\_\_\_\_\_  
In the Matter of )  
Boston Edison Company, et al. )  
(Pilgrim Nuclear Generating Station, )  
Unit 2) )  
\_\_\_\_\_)

TESTIMONY OF PHILIP B. HERR ON PILGRIM 2  
POPULATION DENSITY AND OTHER SITE  
CHARACTERISTICS, SUBMITTED BY INTERVENOR  
COMMONWEALTH OF MASSACHUSETTS  
IN SUPPORT OF ITS CONTENTION NO. 12

Commonwealth Contention 12:  
Neither Applicants Nor Staff Have  
Adequately Considered the Alternative  
of Locating the Proposed Plant at a  
Site More Suitable from a Population  
Density and Environmental Standpoint.

Figure 2.3 - CUMULATIVE POPULATION DISTRIBUTION

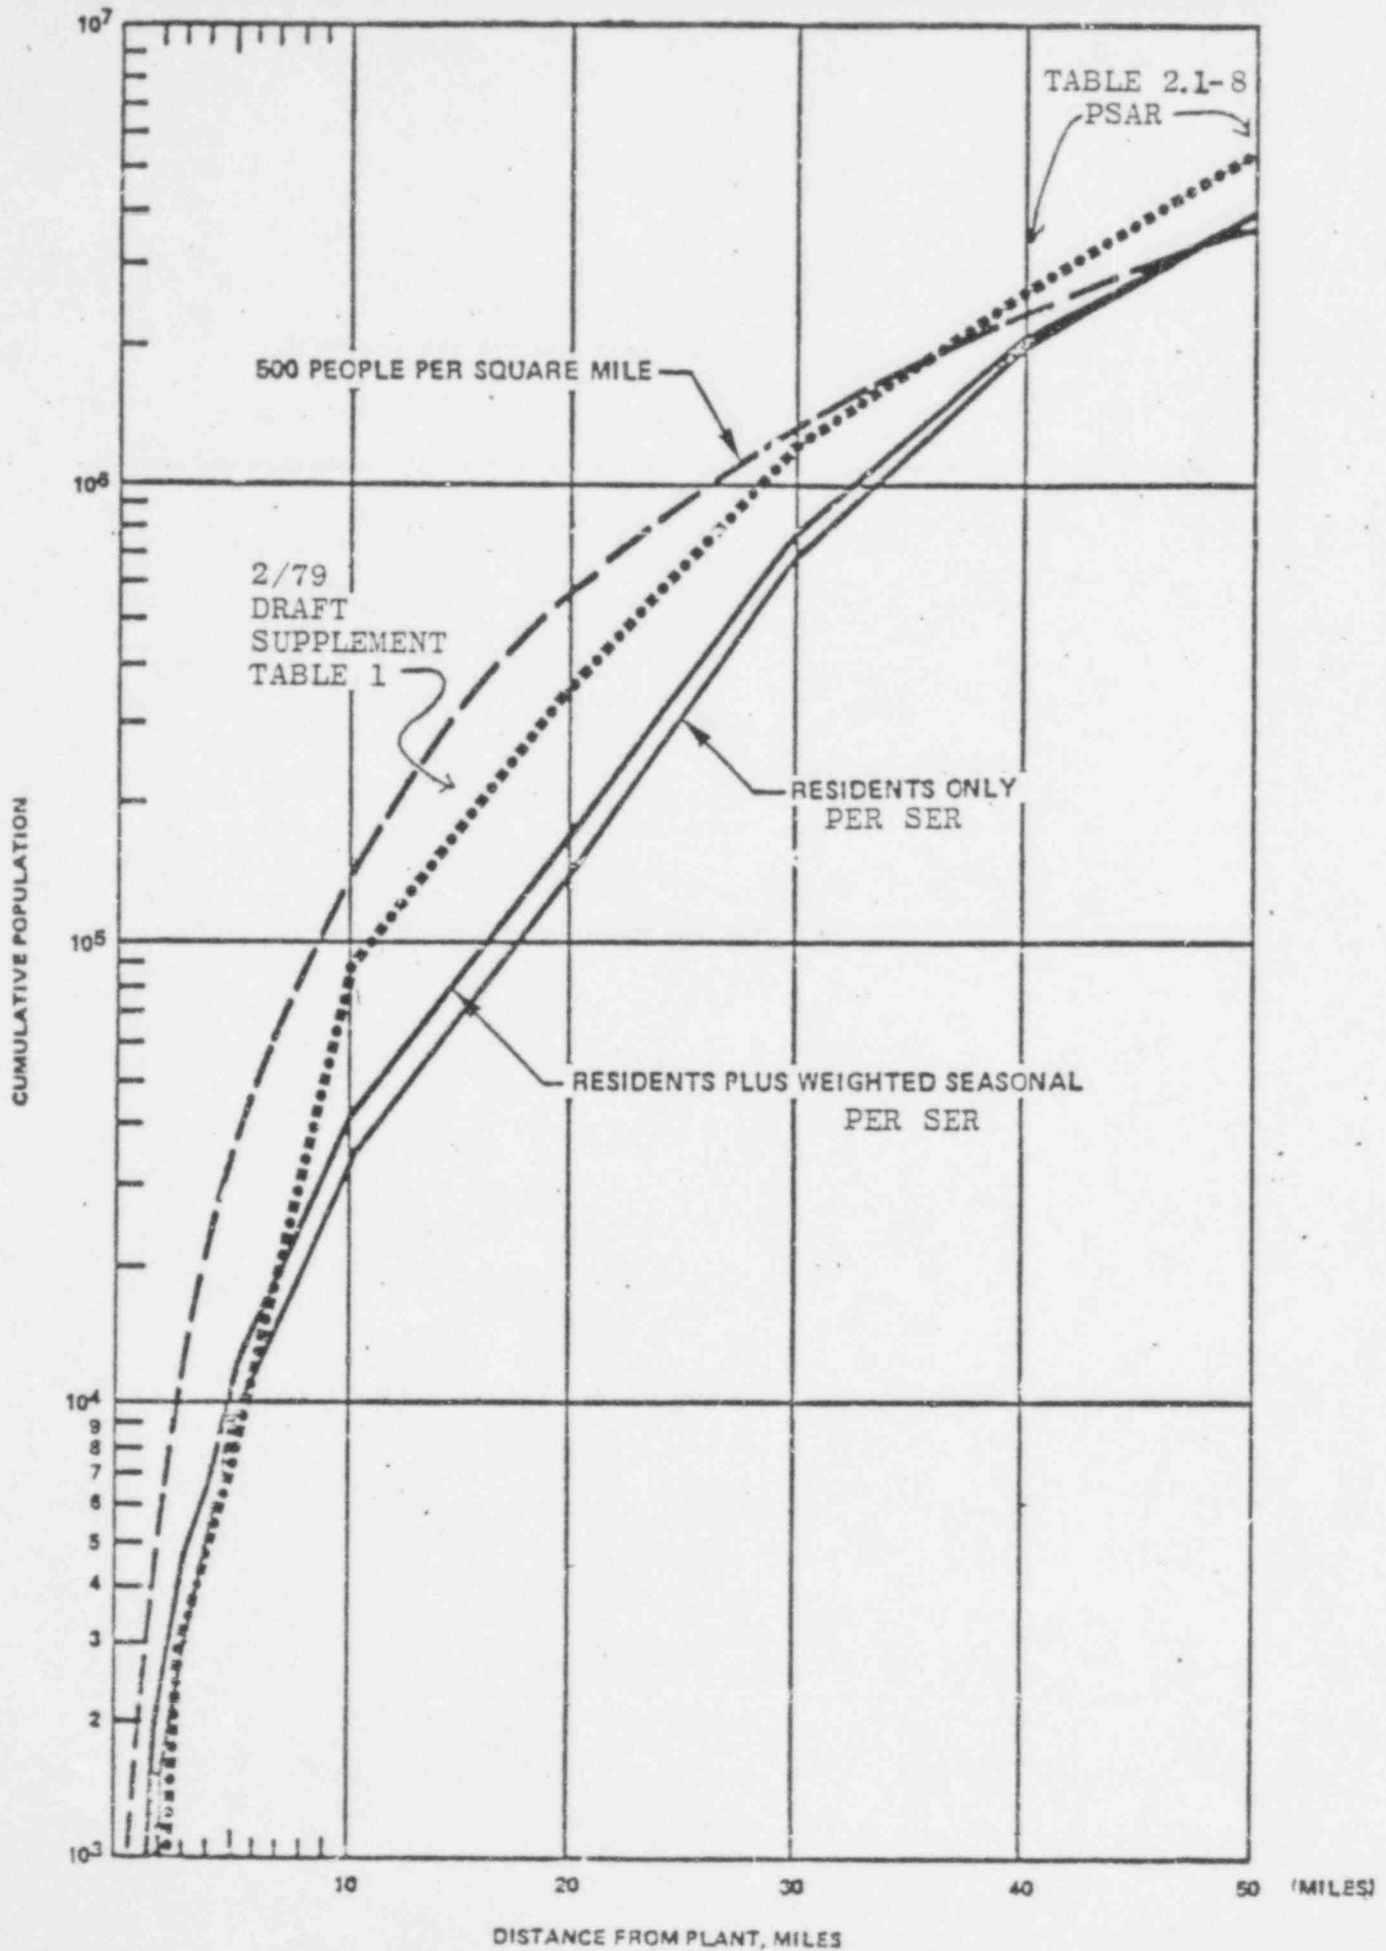
It is noteworthy that beyond ten miles the difference is much smaller between the 500 persons per square mile threshold line and the line plotting the most recent figures than between the recent figures line and the line plotting the earlier SER figures. It is also noteworthy that the 500 person per square mile threshold is reached only a modest distance beyond the 30 mile radius. Furthermore, should the initial year of commercial operation be deferred beyond 1985, the gap between projected population and the Reg. Guide threshold figure would be rapidly narrowed, given the UE&C estimated growth rate of nearly 2% per year.<sup>2/</sup>

plotted on the chart at Figure 1 are understated to this extent. Of particular concern are daytrippers to tourist attractions in Plymouth itself; according to Table 2.1-4 of the PSAR, Mayflower II and the waterfront homes attract 400,000 tourists per year, and are only 4.5 miles west of the Rocky Point site, while Plimouth Plantation attracts 250,000 tourists per year and is only 2.5 miles west of the site. Six miles to the southwest, Myles Standish State Forest attracts 300,000 campers and picnickers per year, and while some double counting clearly is present in the above figures, they all tend to corroborate a Plymouth Chamber of Commerce estimate that nearly one million persons per year currently visit the town.

FIGURE 3:  
PERMANENT POPULATION BY SECTOR, 1990

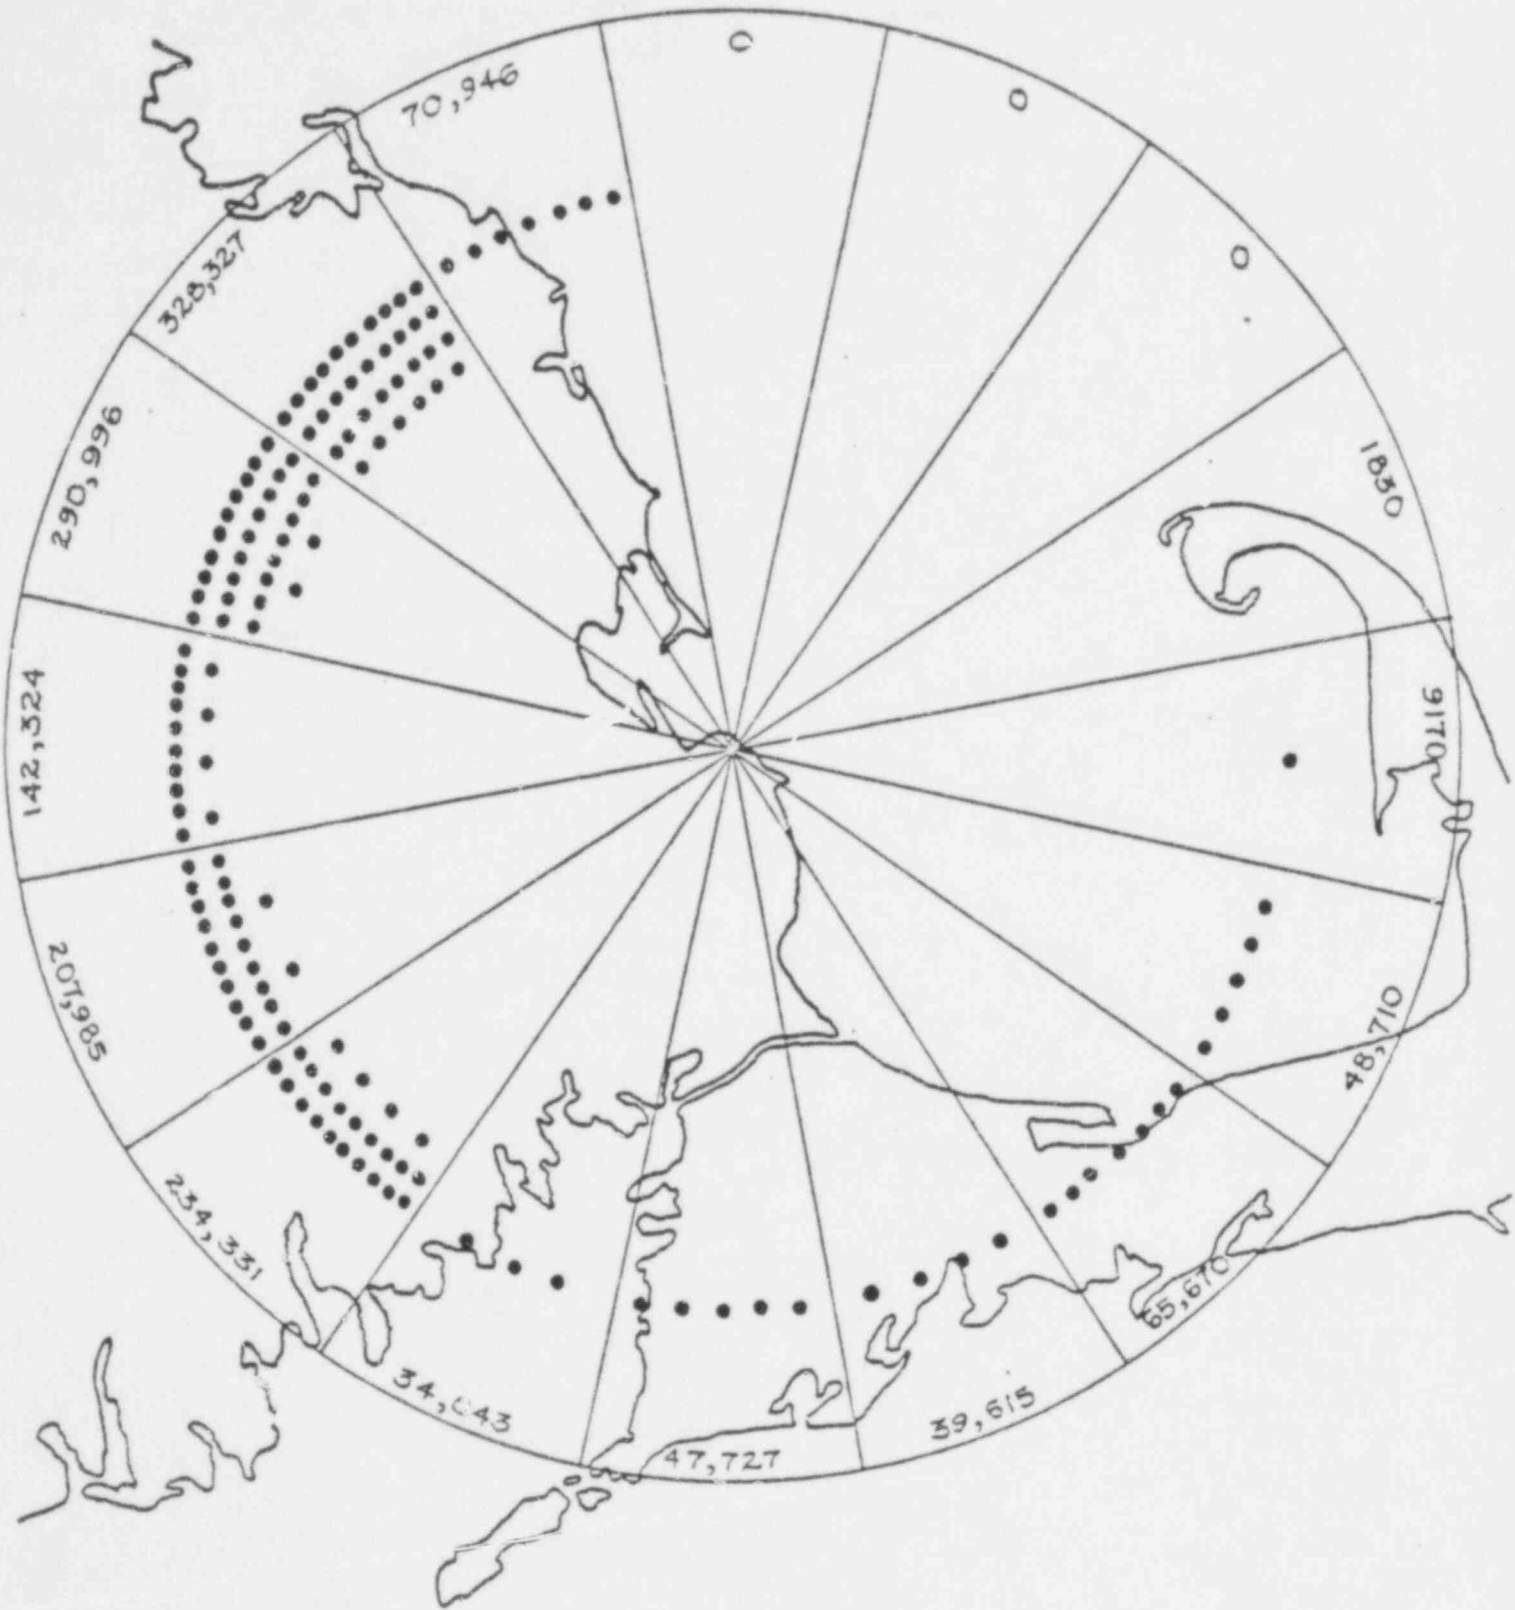
distribution is not narrowly confined to one or two sectors, as indicated by the sectoral standard deviation of 97,591. Figure 3 illustrates geographically where the sectors of cumulative permanent population occur around the Rocky Point Site.

The population density of the region northwest of the Rocky Point site is dramatically high. Nearly one half of the cumulative permanent population within 30 miles of the site is concentrated in the two northwesterly sectors (See Table A and Figures 3 and 4).<sup>6/</sup>

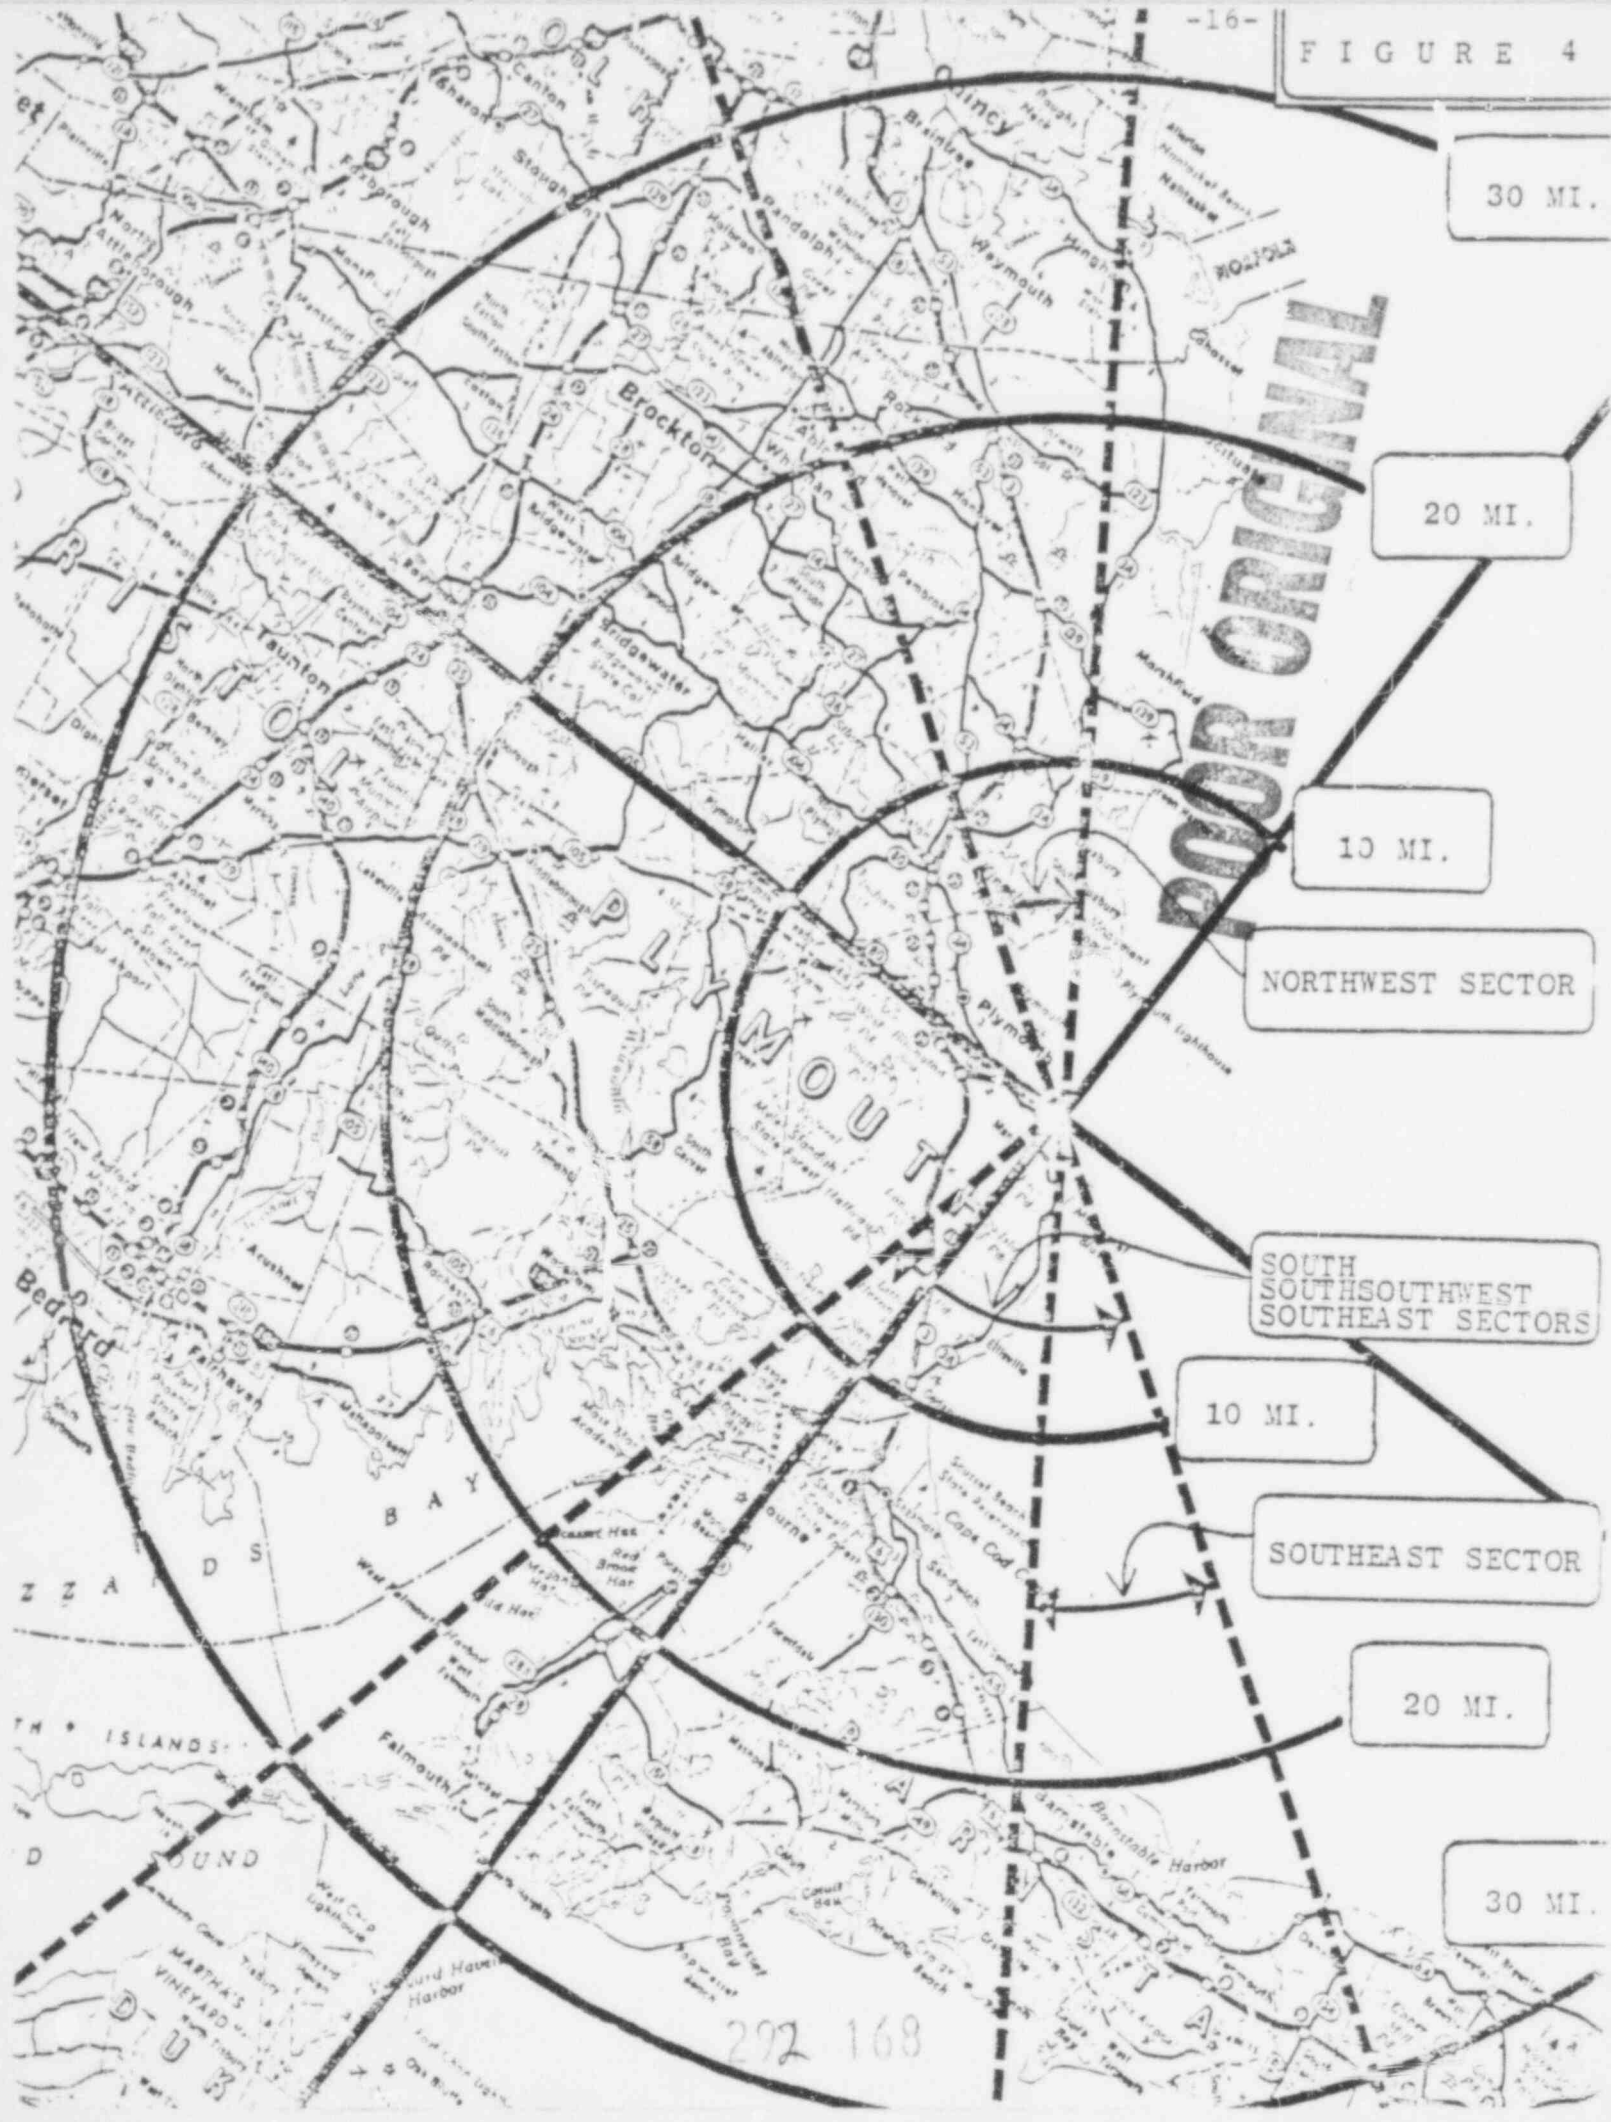
Egress configurations and limitations makes the southeast situation in the event of a major accident even more serious than population density suggest. As Figures 4 and 5 illustrate, there are special site circumstances regarding evacuation routes from the vicinity of Rocky Point, especially for population south or southwest of that site. Because of the presence of the Myles Standish State Forest and a vast largely undeveloped area, movement southwesterly through that area is possible only over a rudimentary maze of narrow, winding two-lane roads, many unpaved and discontinuous, all of them poorly marked.
